UNITED STATES PATENT AND TRADEMARK OFFICE

| Office Action Summary | Application No. 10/608,400 | Applicant(s) PUGIA ET AL. | |

DETAILED ACTION***Double Patenting***

**Fig. 3a****Fig. 3b**

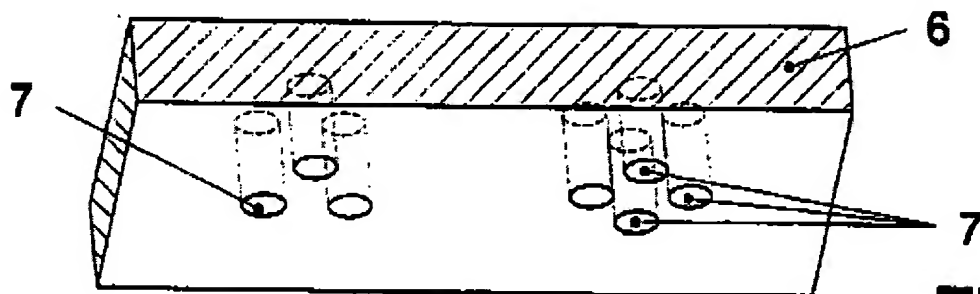
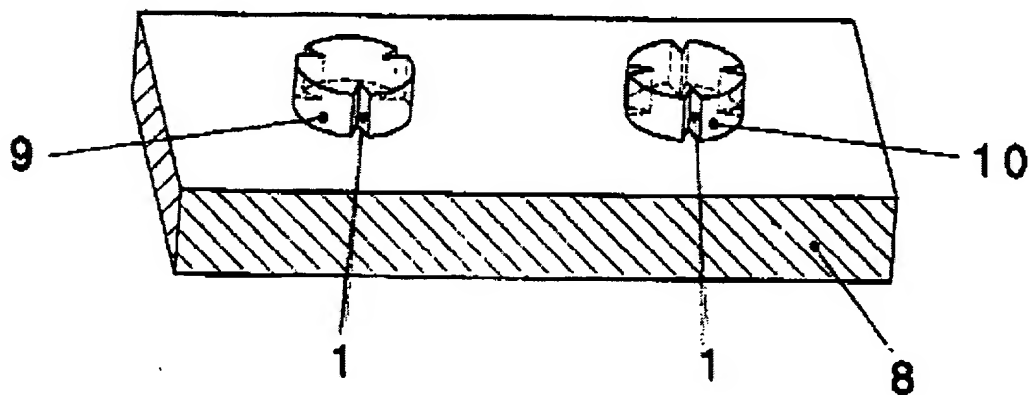
Peters teaches an apparatus comprising a uniform array of posts (e.g., columnar projection 2) and a vent opening (36) that serves to uniformly distribute or wet the interior surface of the apparatus to facilitate effective optical analysis (see, e.g., col. 3, line 7 – col. 4, line 14; col. 4, lines 50 – 67; col. 6, lines 14 – 32; col. 6, lines 58 – 67; col. 7, lines 1 – 22; figures 3a, 3b, 7b & 8).

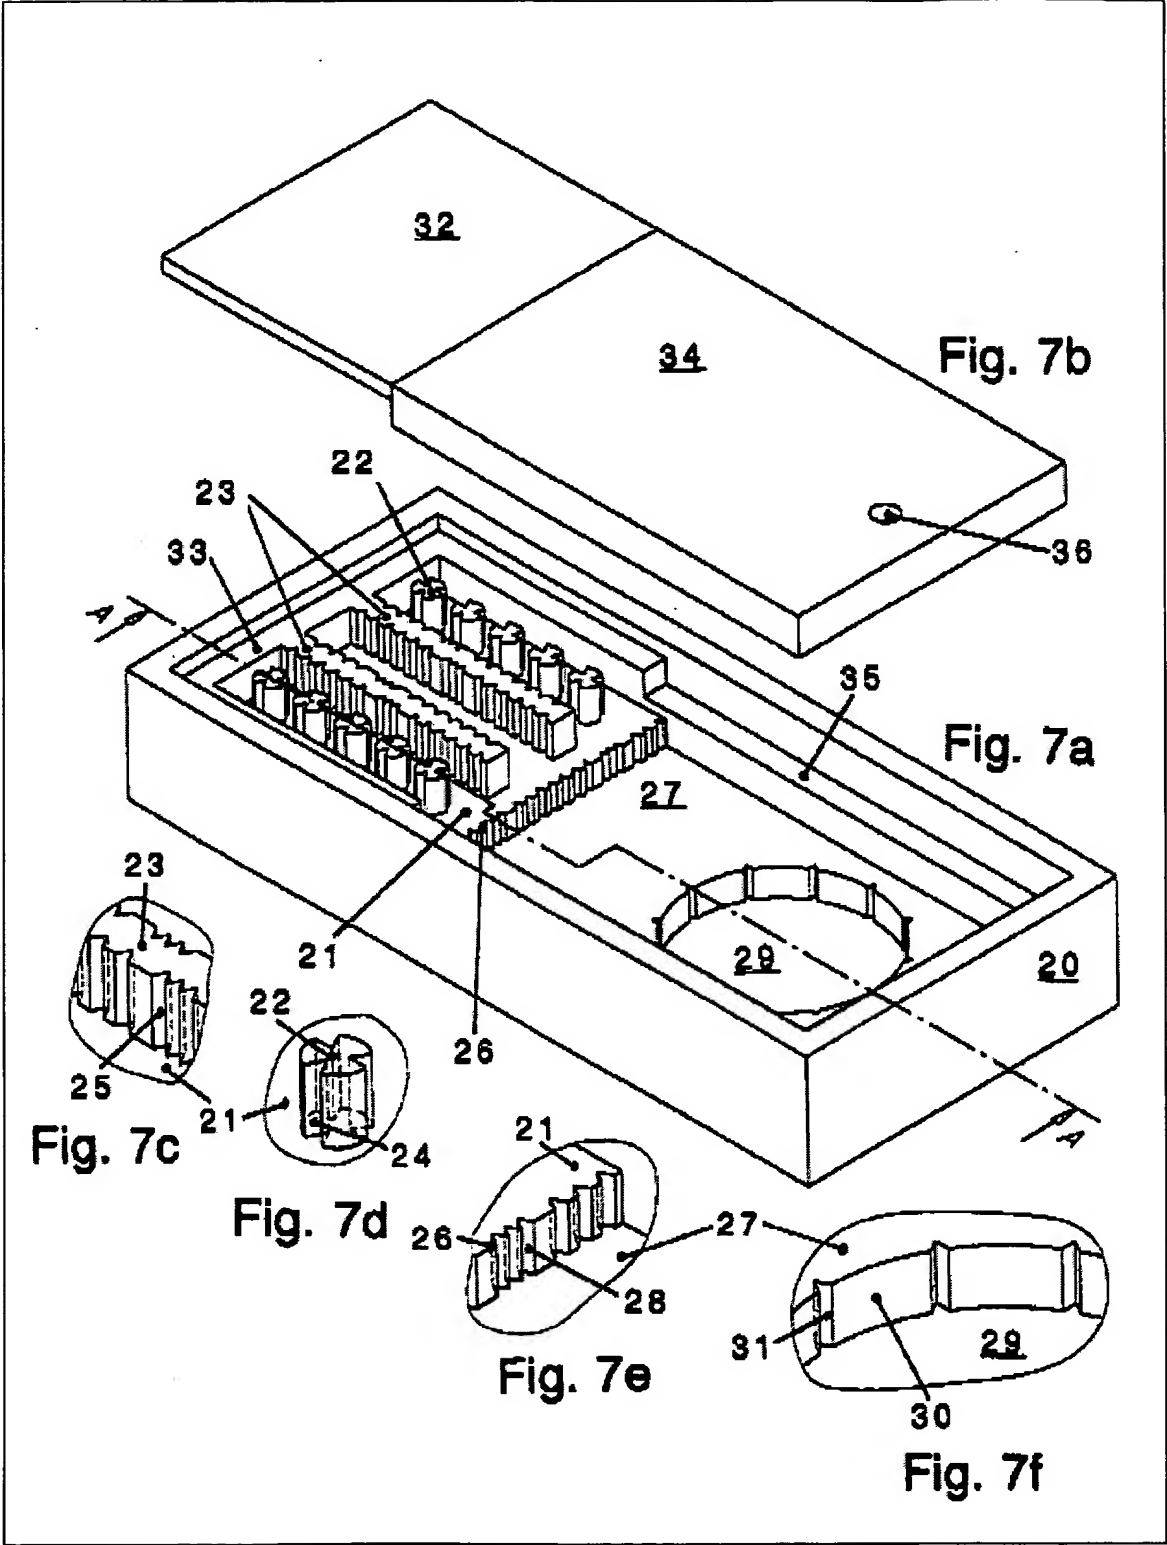
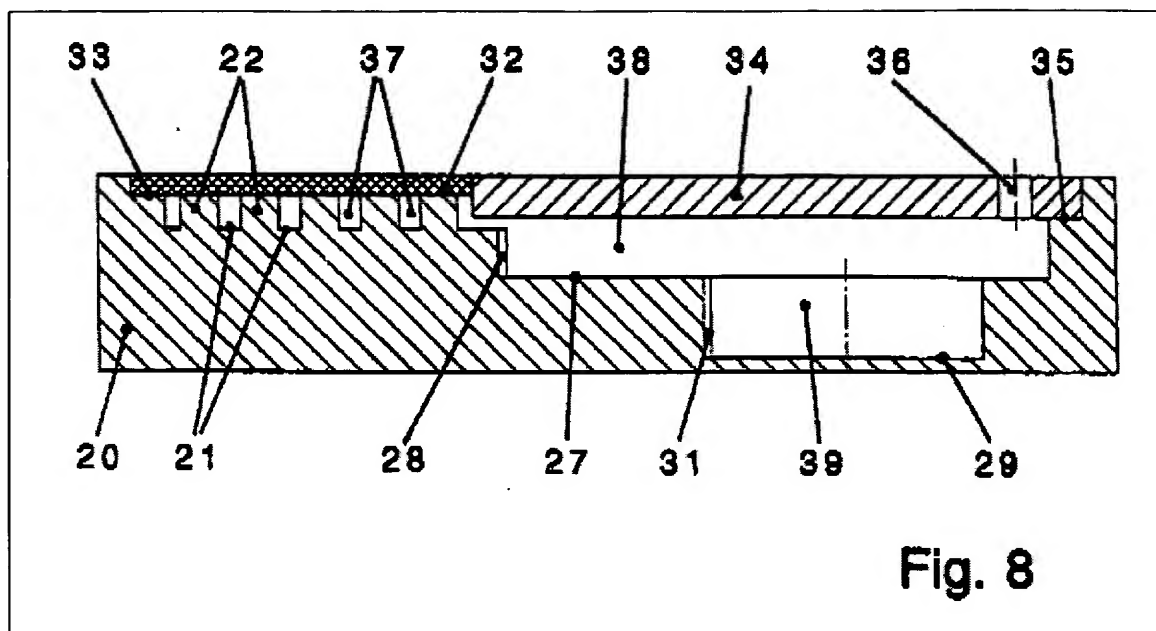
Regarding claim 3, Peters teaches that the posts or columnar projections 22 may be arranged in any desired spatial arrangement and including a plurality of secondary posts (e.g., 23 & a second set of columnar projections 22 (not labeled) as shown in figure 7b (see col. 6, lines 58 – 67; figure 7b).

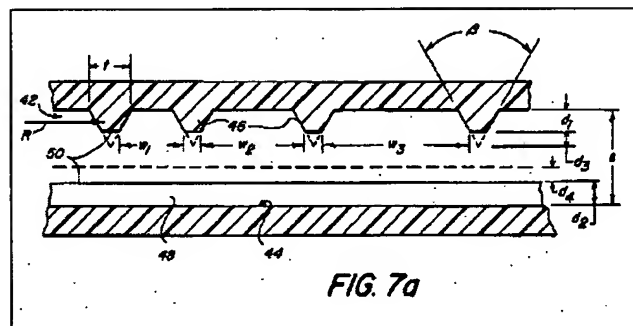
Regarding claims 5 and 6, Peters teaches that the posts 22 can be arranged on top of or above and in contact with a substrate portion (e.g., the surface of base 21) (see figures 7a and 7b).

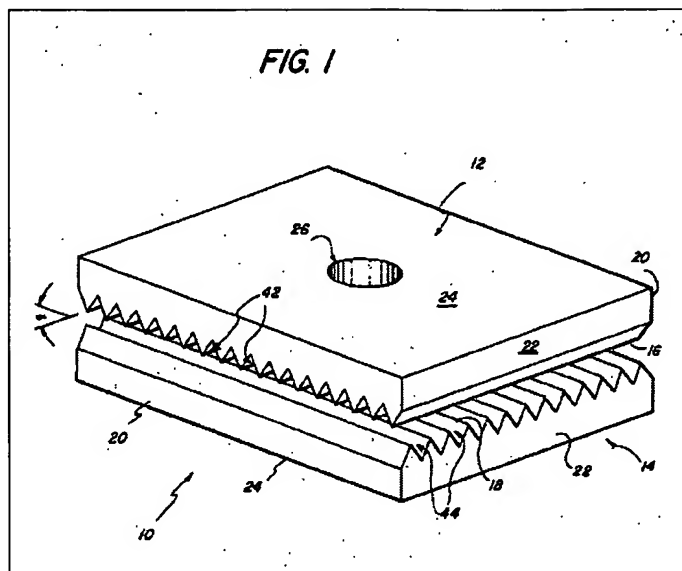
Regarding claim 8, Columbus teaches an analytical apparatus (10) comprising: at least one space (e.g., the space between interior surfaces 16 & 18) for containing a test sample and a reagent on a substrate (e.g., the bottom surface 18); a microstructure (grooves 42 & 44) disposed in the space for directing the test sample over the substrate in a uniform manner. As fluid is introduced into the space via port 26, the introduced fluid would displace and thereby purge any air contained within this space during use (see col. 3, line 16 – col. 4, line 68; figure 1).
